**Request for Construction Change  
Change Order No. 1**

Contract No. 2017-0131  
Project 54" Southeast Interceptor Sewer  
Emergency Repair

**Re: Request for Emergency Quote: 54" Southeast Interceptor Sewer Emergency Repair  
414 LF SMH10324-SMH10686,**

**DEBRIS IN PIPE**

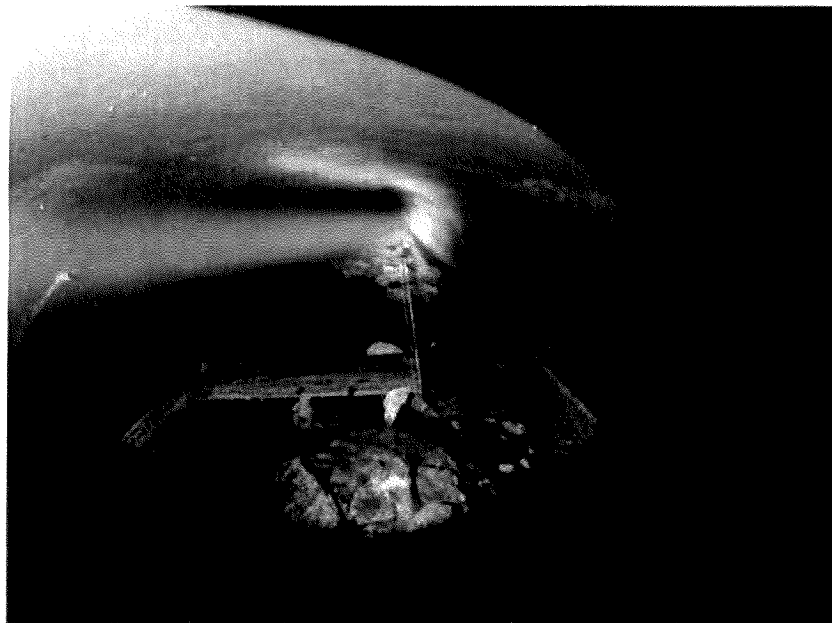
**Notes: Repair/Replacement -5**

1. Photo taken from upstream SMH-10324 facing downstream direction toward SMH-10686,
2. Pipe is filled to approximately 1 ft depth with debris consisting of stone ranging in size from gravel to large surge stone rip rap, sediment, construction debris (plywood), sanitary material, etc.
3. Pipe must be cleaned and/or replaced to provide the City with reliable service.

The City has compared the costs of cleaning the pipe with risks associated to replacing the pipe between the two manholes. The City believes it's in the best interest for the health and safety of Franklin's residents to replace the pipe in it's entirety.

## **TRENCH DETAIL**

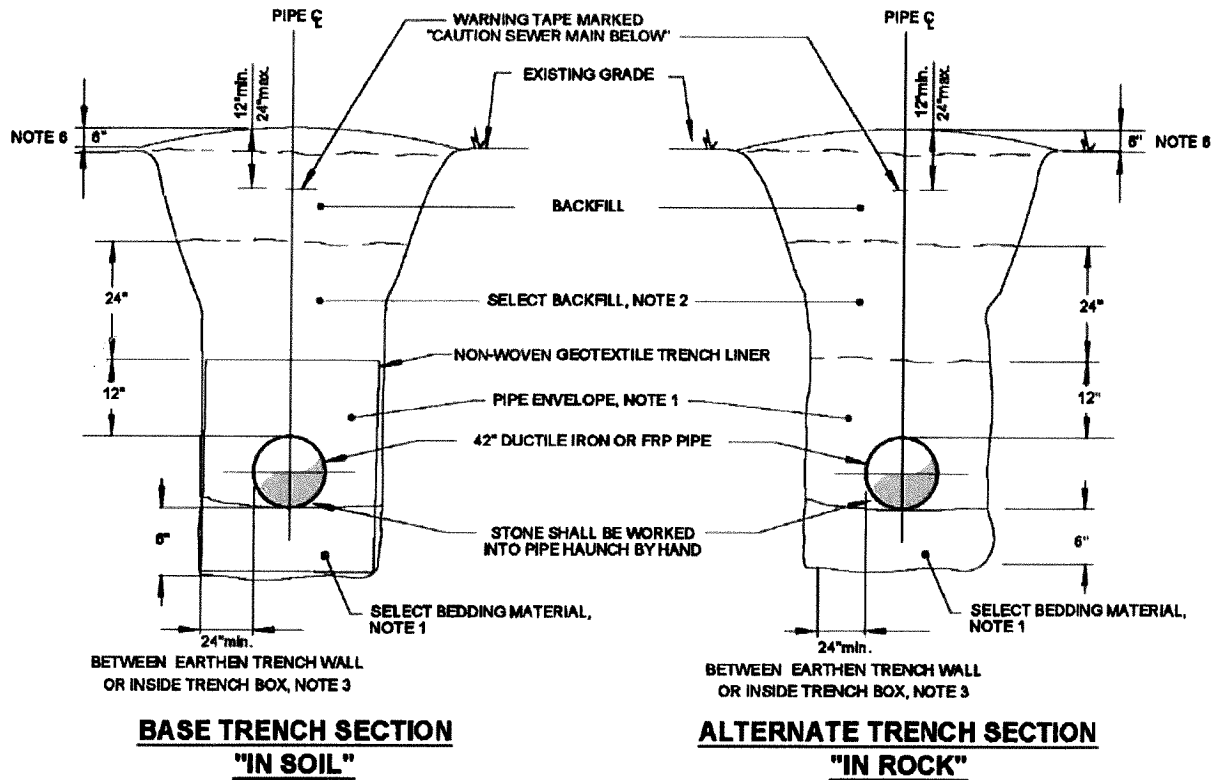
1. SELECT BEDDING AND PIPE ENVELOPE BACKFILL SHALL BE PLACED TO A 24-INCH MIN. DEPTH OF COVER OVER PIPE. REFER TO THE ATTACHED SPECIFICATION FOR MATERIAL CHARACTERISTICS.

2. THE SELECT BACKFILL SHALL BE A MATERIAL FREE FROM ROCKS GREATER THAN 2" dia., SOIL CLODS, OR FROZEN MATERIAL. WHEN AUTOMATIC TAMPERS ARE USED, CARE SHALL BE EXERCISED TO AVOID DAMAGE TO THE PIPE.

3. A MINIMUM OF 24 INCHES OF CLEAR SPACE IS REQUIRED BETWEEN EACH SIDE OF THE PIPE AND THE EARTHEN TRENCH WALL OR INSIDE FACE OF THE TRENCH BOX (IF USED).

4. GEOTEXTILE SHALL BE A MINIMUM 8-OUNCE PER SQUARE YARD (NOMINAL) NONWOVEN NEEDLE PUNCHED SYNTHETIC FABRIC CONSISTING OF STAPLE OR CONTINUOUS FILAMENT POLYESTER OR POLYPROPYLENE MANUFACTURED IN A MANNER ACCEPTED BY THE ENGINEER AND THE OWNER. GEOTEXTILE SHALL BE INERT AND UNAFFECTED BY LONG TERM EXPOSURE TO CHEMICALS OR LIQUIDS WITH A PH RANGE FROM 3 TO 10. GEOTEXTILE SHALL HAVE A SURVIVABILITY CLASS OF CLASS 1 OR 2 IN ACCORDANCE WITH AASHTO M288, UNLESS OTHERWISE SPECIFIED HEREIN. ACCEPTABLE PRODUCTS ARE MIRAFI 180N OR EQUIVALENT.

5. ALL SEWER LINE TRENCHES SHALL BE MECHANICALLY COMPACTED PER SPECIFICATION, (FULL DEPTH).
6. TRENCH SHALL BE CAPPED OFF WITH A 6" MOUND OF TOP SOIL. ADDITIONAL OFFSITE MATERIAL REQUIRED SHALL BE INCIDENTAL TO THE UNIT PRICES AVAILABLE.

7. PIPE BEDDING AND COMPACTED BACKFILL SHALL BE INCIDENTAL TO THE UNIT PRICE FOR SEWER LINE.
8. ENGINEER SHALL DETERMINE WHICH TRENCH SECTION SHALL APPLY BASED ON CHANGING FIELD CONDITIONS.
